Clean Harbors Aragonite, LLC
11600 North Aptus Road
Aragonite, UT 84029

August 26, 2019

**RE: Class 3 Modification Request for Acceptance of 1.3G Explosives
Clean Harbors Aragonite, LLC. (CHA)
EPA ID No. UTD981552177**

SITE PLAN

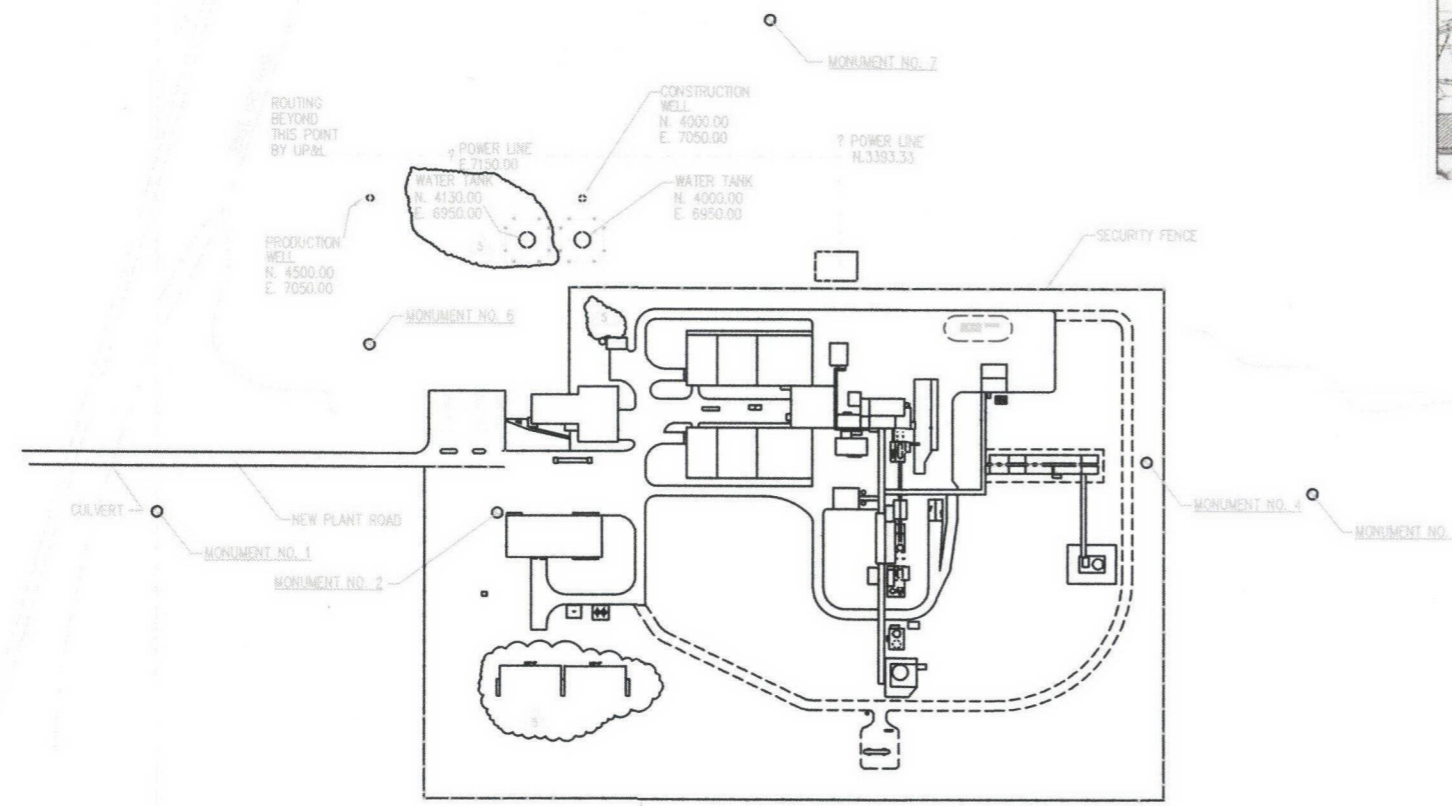
In the event storage is needed CHA will store these in three Type 4 Magazines in accordance with the requirements of 27 CFR Part 555 Subpart K. 27 CFR Part 555 Subpart K defines a Type 4 magazine as a building, igloo or "Army-type structure", tunnel, dugout, box, trailer, or a semitrailer or other mobile magazine. CHA will use metal boxes fitted with hinges and hasps with two padlocks fastened in separate hasps and staples. The padlocks will be protected with not less than ¼ inch steel hoods. These magazines will be placed via roll off truck in the maintenance storage area west of the maintenance building at a distance of no less than 50 feet from the facility fence line, 190 feet from inhabited buildings and 125 feet from other magazines in accordance with the Table of Distances requirements found in 27 CFR part Subpart K 555.219 and as shown in the attached drawing D-034-M-001, MK966, Rev 5 with Magazines PDF. The magazines will be placed on rail ties to elevate off the ground in case of a precipitation event, the ground will be slopped for drainage. CHA will track the movements of each pallet, and each broken down ammo can in and out of the magazines.

- Module 2,
- Module 3,
- Attachment 1-Waste Analysis Plan,
- Attachment 3- Inspections,
- Attachment 7-Closure Plan and
- Appendix 1 – Closure Cost Estimates
- Drawing D-034-M-001, MK966, Rev 5
